TRANS/WP.29/644  
16 February 1999

Working Party on the Construction of Vehicles

DRAFT SUPPLEMENT 9 TO THE 04 SERIES OF  
AMENDMENTS TO REGULATION No. 16

(Safety-belts)

Insert a new example of an approval mark, to read:

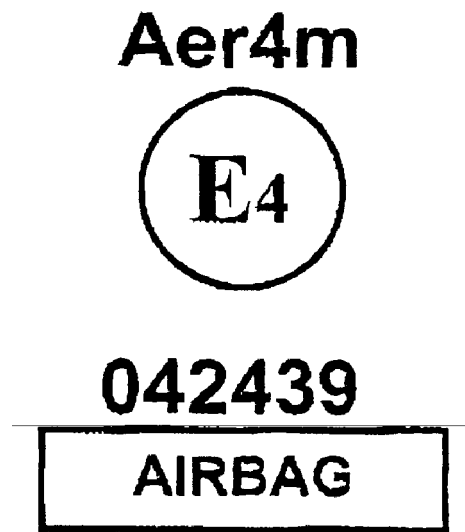
The safety-belt bearing this type-approval mark is a three-point belt ("A") fitted with an energy absorber ("e"), approved as meeting the specific requirements of paragraph 6.4.1.3.3. of this Regulation, and with a multiple-sensitivity ("m") type 4 ("r4") retractor, in respect of which type-approval was granted in the Netherlands ("E4") under the approval number 042439. The first two digits indicate that the Regulation already incorporated the 04 series of amendments at the time of the approval. This safety-belt has to be fitted to a vehicle equipped with an airbag in the given seating position."
